**APPLICATION FOR  
URBAN DESIGN COMMISSION  
REVIEW AND APPROVAL**

PROJECT ADDRESS: 25 W. MAIN ST., MADISON, WI 53703

# PROPOSED CHANGES TO THE REDEVELOPMENT OF ANCHOR BANK

submitted as a minor alteration to previously  
approved conditional use by the City of  
Madison and the Urban Design Commission

# CORNER PARKING STAIR ENTRANCE DETAIL

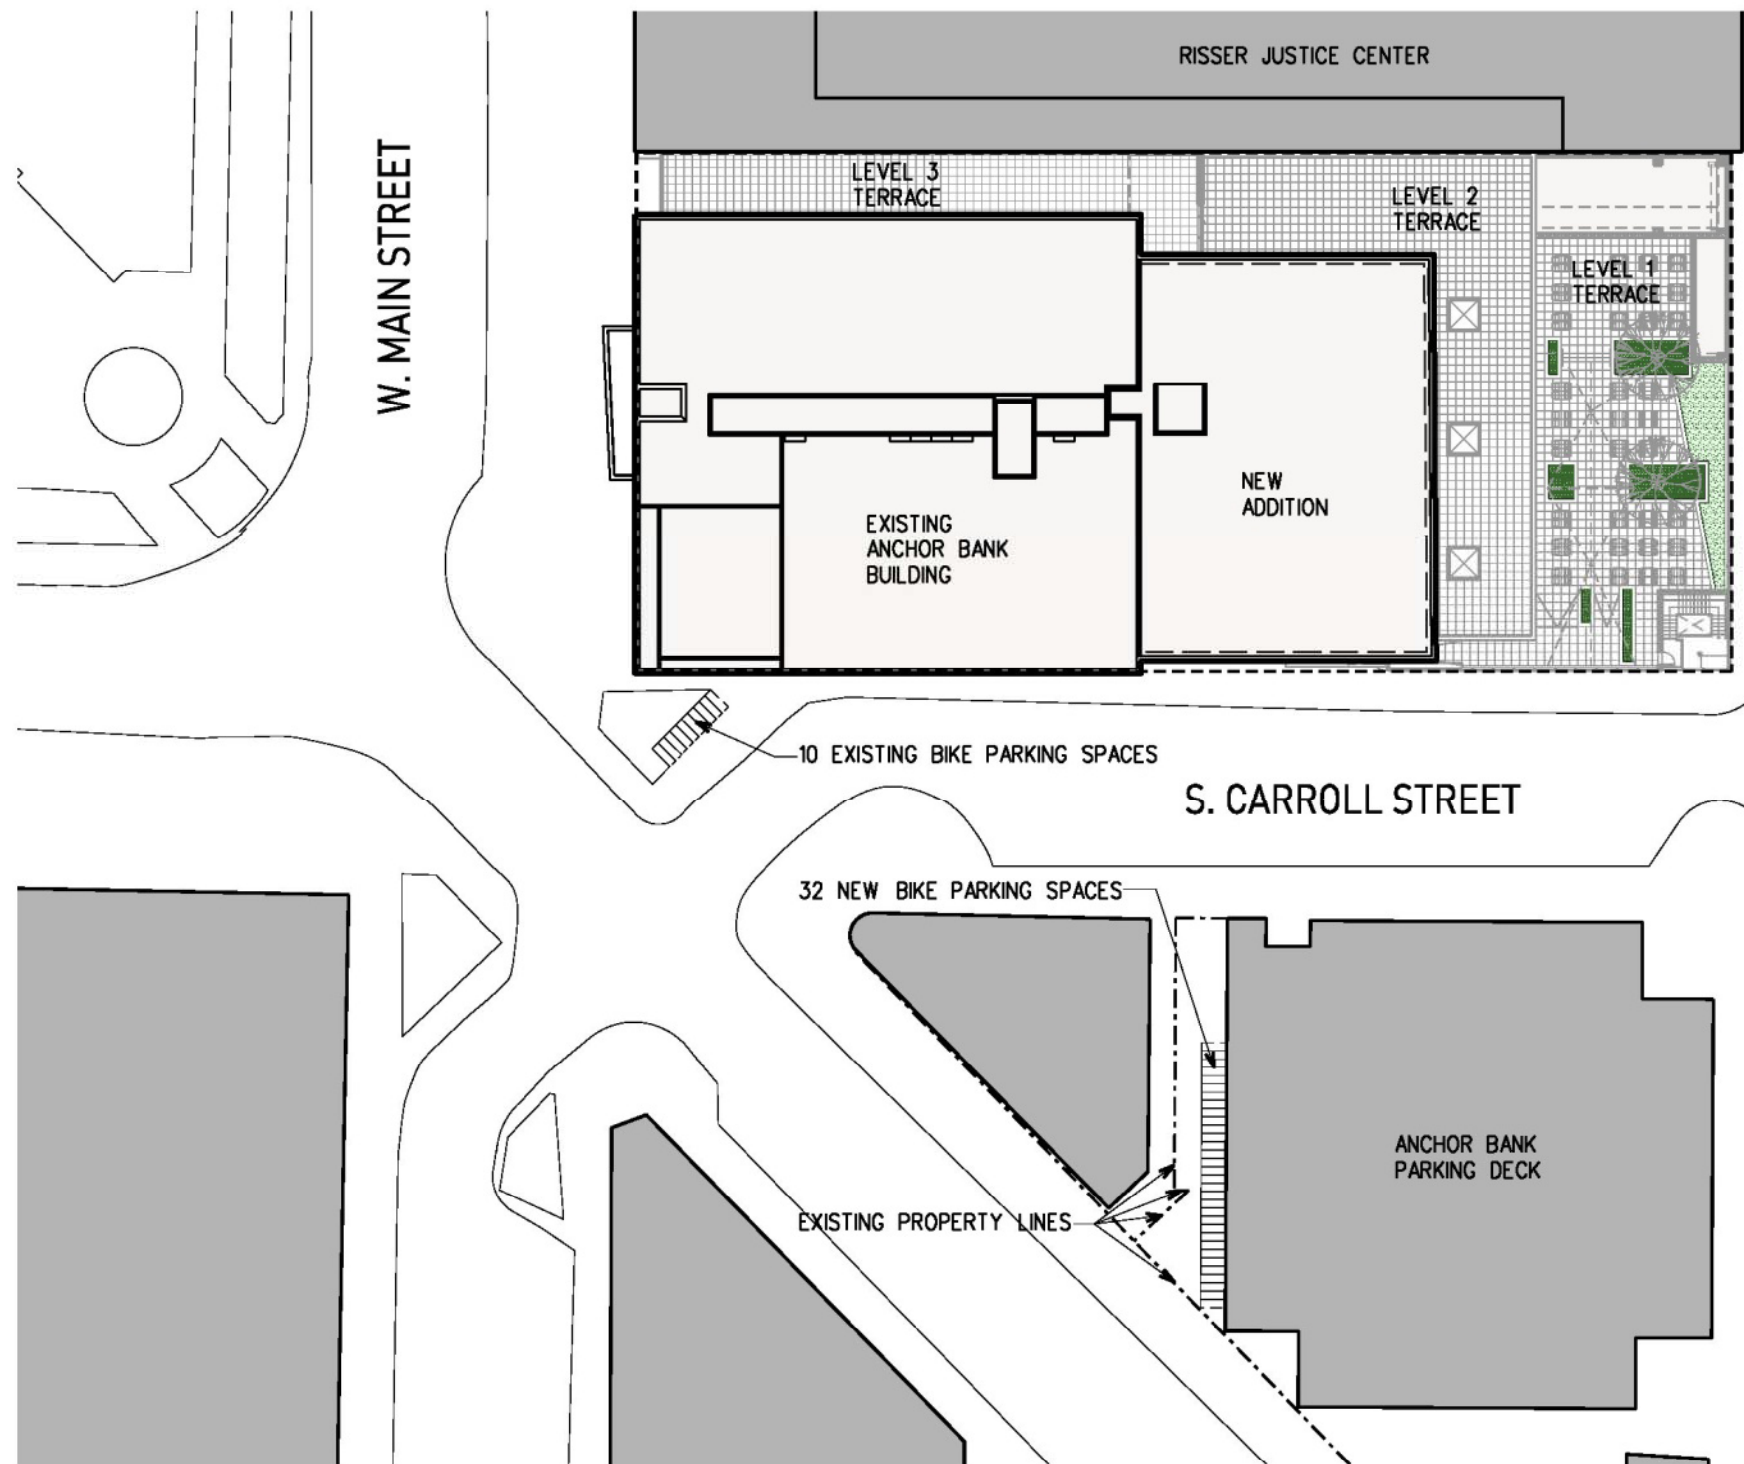
THE DESIGN OF THE PARKING EXIT STAIR AT  
THE CORNER OF CARROLL & DOTY STREETS  
HAS BEEN IMPROVED TO BE MORE  
CONSISTENT WITH THE SOPHISTICATED  
DESIGN OF THE BUILDING
